**Servicing and Stormwater  
Management Report  
CHEO Parking Garage  
401 Smyth Road, Ottawa, ON**

**EXP Project Number:** MRK-21023468-A0

**Type of Document:**  
Site Plan Control Application

FIGURE 3 - VHV

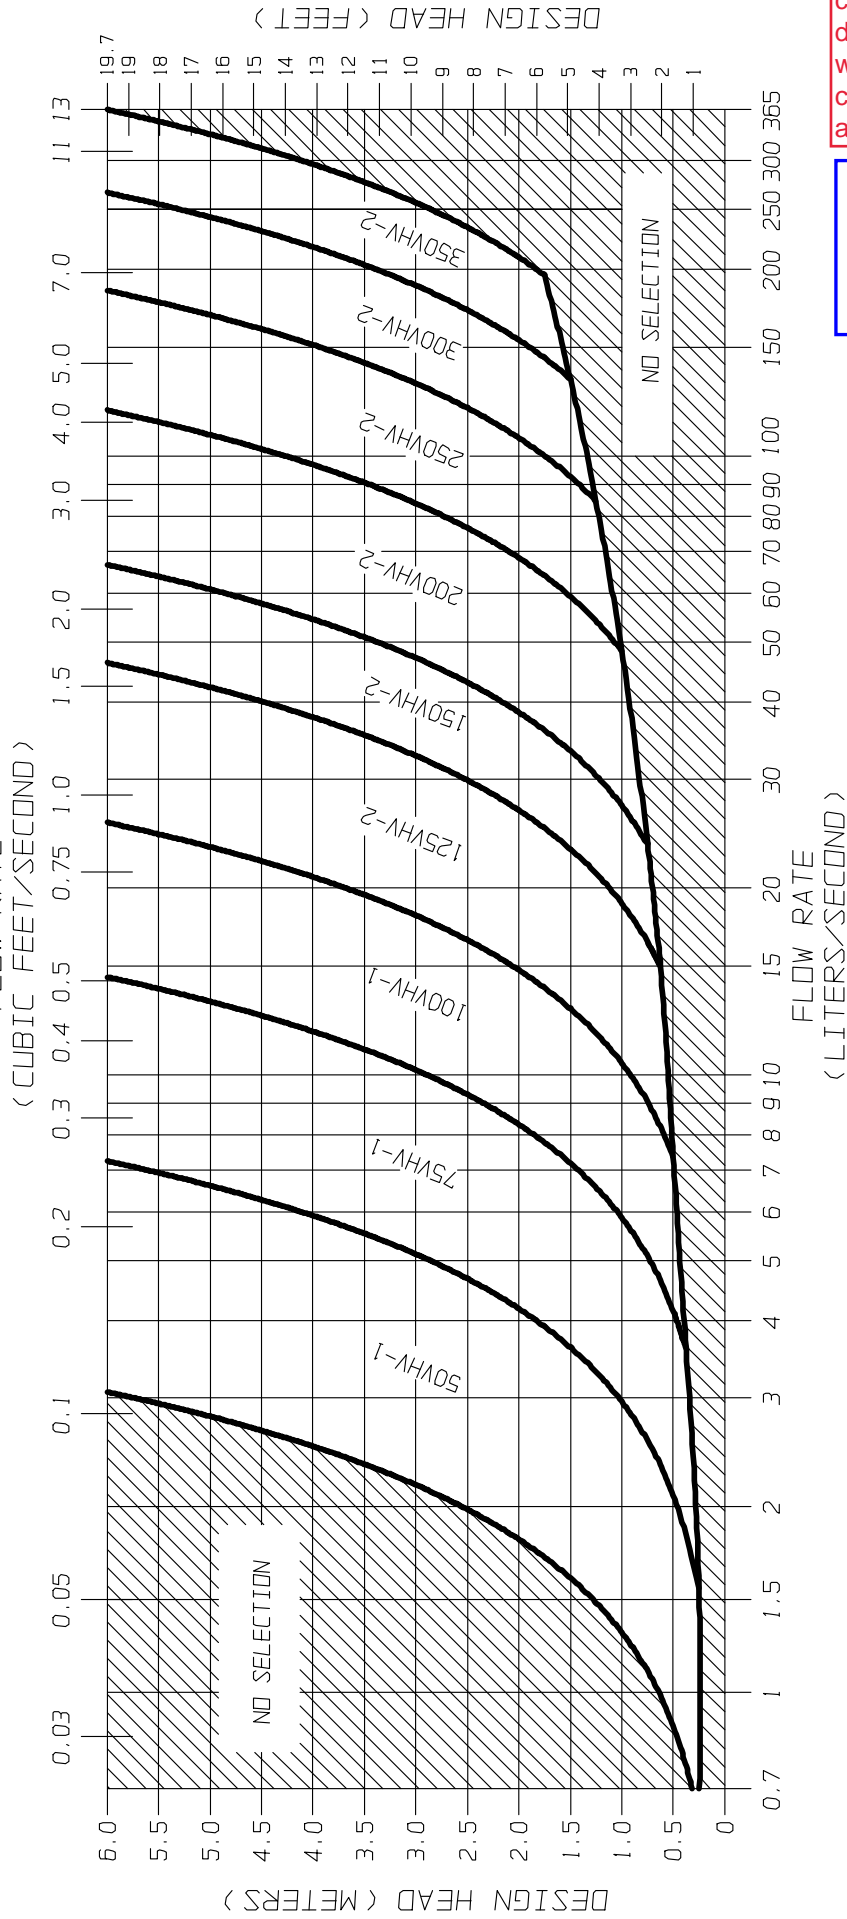
Please provide completed charts to determine which model was selected for each controlled drainage area.

PDC Response: Ok. ProjectCo to clearly identify how ICD models were selected, if applicable.
